RFQ NUMBER  
**DEFK8037**

Re: Pre-Bid Meeting; Eleanor Road Security/Force Protection, Eleanor, WV

Addendum No. O-1  
November 7, 2007

Subj: **ADDENDUM BULLETIN NO. O-1**

**(A) TYPICAL SECTION ASPHALT ROAD**  
NOT TO SCALE

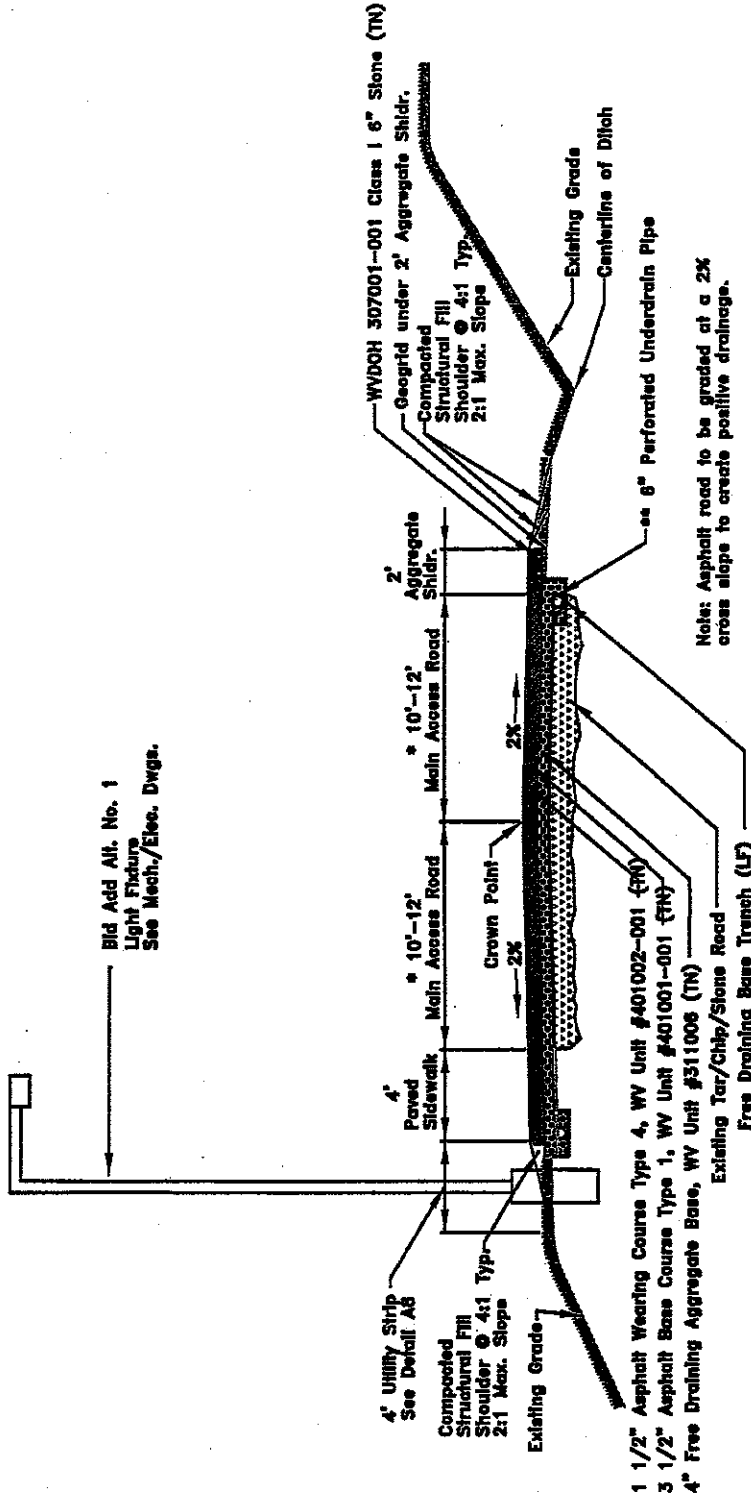
1. Drawing SP-7 Detail A/7: DELETE Detail A/7 on Sheet SP-7. ADD Revised A/7 Sheet SP-7 dated 11/7/07 to change the 1" asphalt wearing to 1 ½" and the 4" asphalt base to 3 ½".

- 1 1/2" Asphalt Wearing Course Type 4, WV Unit #401002-001 (TN)
- 3 1/2" Asphalt Base Course Type 1, WV Unit #401001-001 (TN)
- 4" Free Draining Aggregate Base, WV Unit #311006 (TN)
